MIN-X RADIO, INC.	
PULSE PROPORTIONAL TRANSMITTER	
"PULSMITE 800S"	
MODEL: TT-1P	DRAWN BY: G.W.R. REVISED BY: RJS

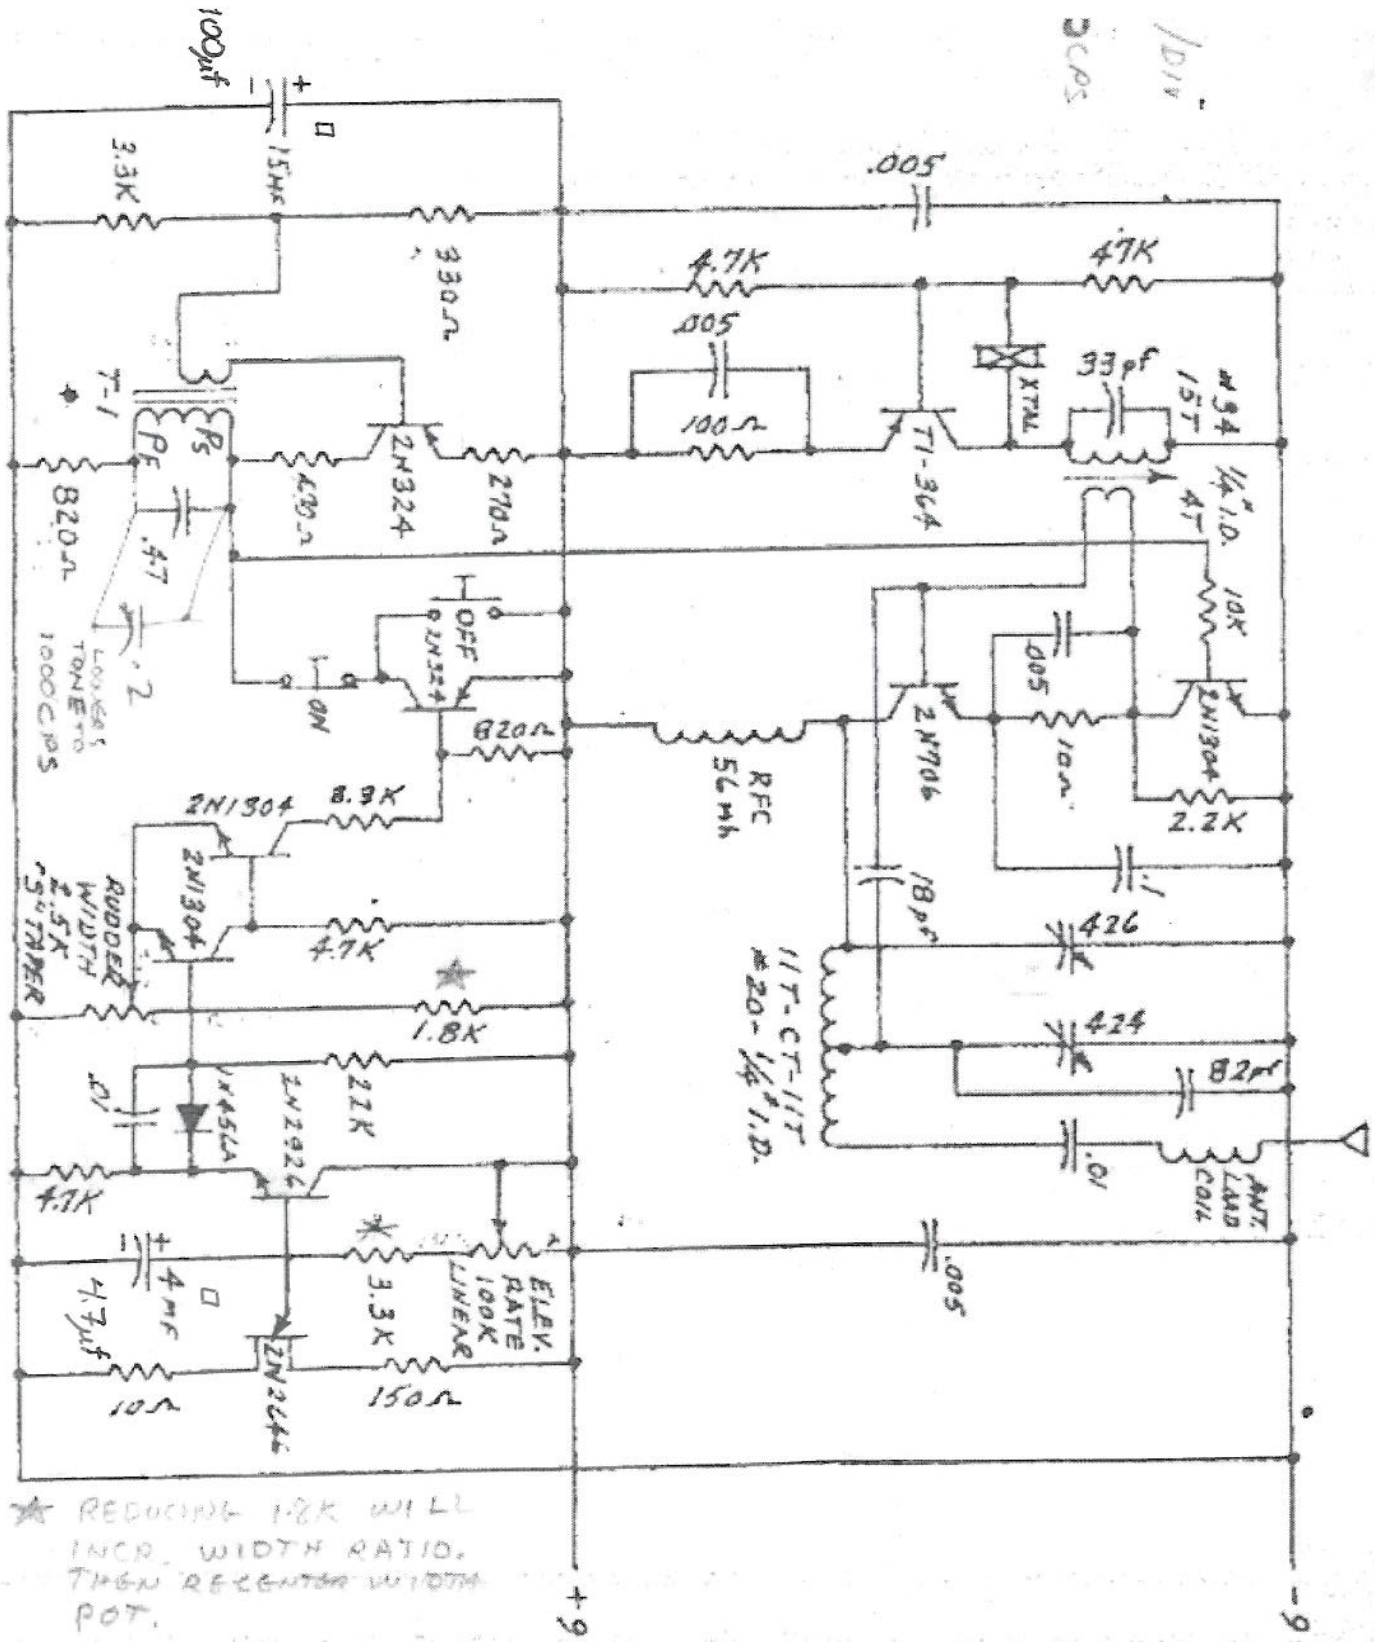
REPLACE

REDUCING 1.8K WILL INCR. WIDTH RATIO. THEN RECENTER WIDTH POT.

NOTE: T-1 HAS 2000 TURNS
PRIMARY - 350 TURNS
SECONDARY - #34 - 5/16" ID

NOTE: PULSMITE 1200S TX
T1 PRIMARY 1400 TURNS
T1 SEC. 275 "

* DECREASING THIS RESISTANCE RAISES RATE
